**Highgate CAAC objection to [HGY/2026/0956](#), 490-492 Archway Road,
London, N6 4NA**

Installation of Electric Vehicle Charging Infrastructure on the carriageway adjacent to 490-492 Archway Road, London, N6 4NA.

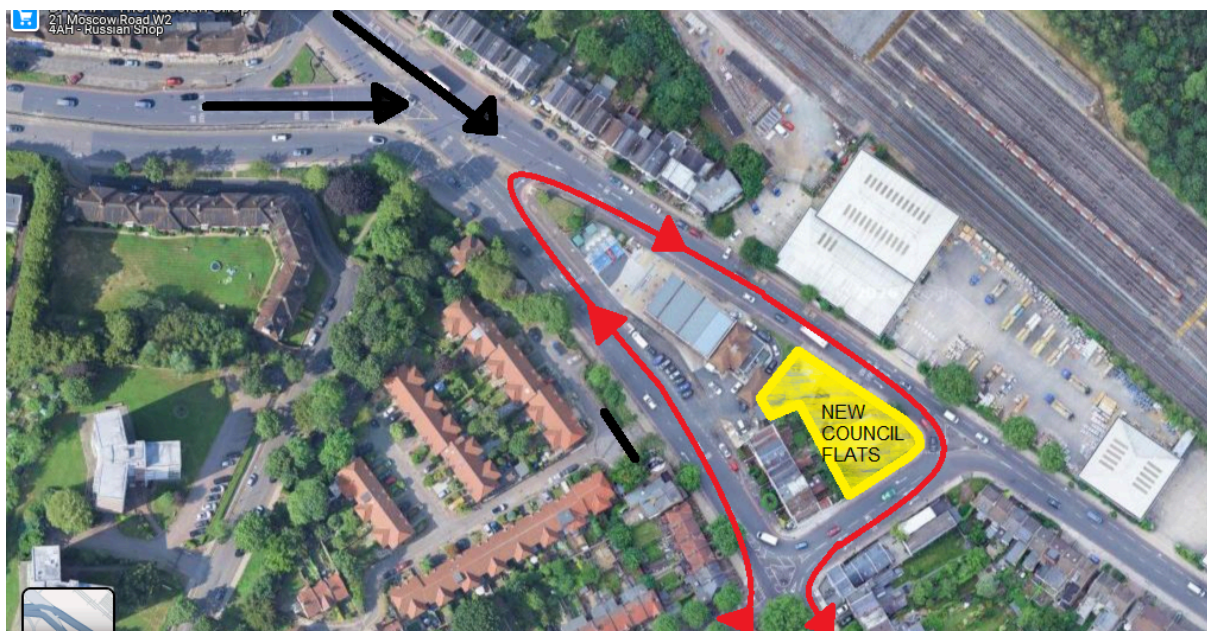
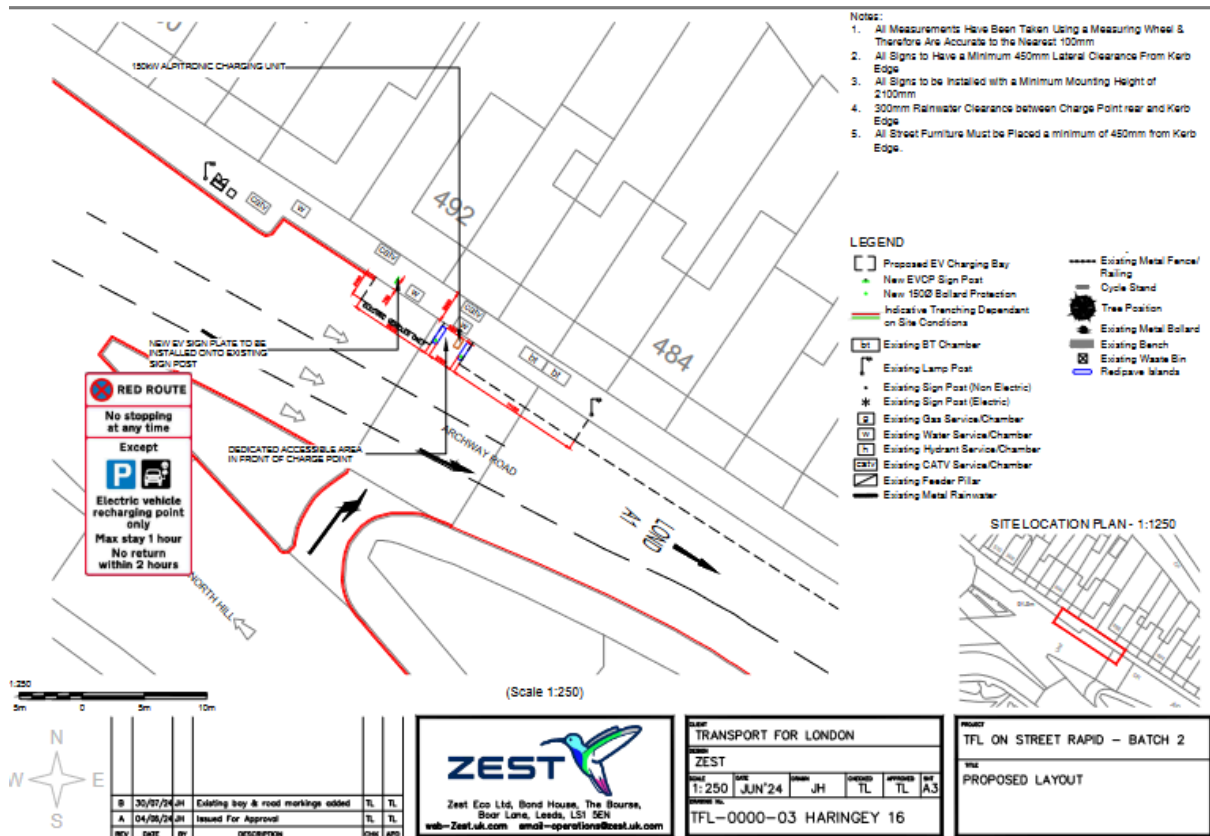
2. The proposed location is also likely to increase the danger facing traffic using the slipway around the petrol station, e.g. to leave Gaskell Estate and head south towards Highgate or Archway.

Turning right from Kenwood Road onto North Hill is not permitted. If residents, allotment holders, school traffic etc want to travel southwards up North Hill or Archway Road they are obliged to turn left and go round the gyratory using the sliproad facing the proposed EV charging location. This is already a dangerous manoeuvre. Narrowing the road directly in front of this small turning and adding EVs trying to get in and out of the charging spaces while traffic heads directly at them merging from the A1 and A1000 is likely to be very dangerous - see diagrams below.

Narrowing the road and adding manoeuvring EVs at the point where traffic from the A1 and A1000 attempts to get into the correct lane towards Archway or Highgate seems very ill advised and liable to increase collisions and injuries.
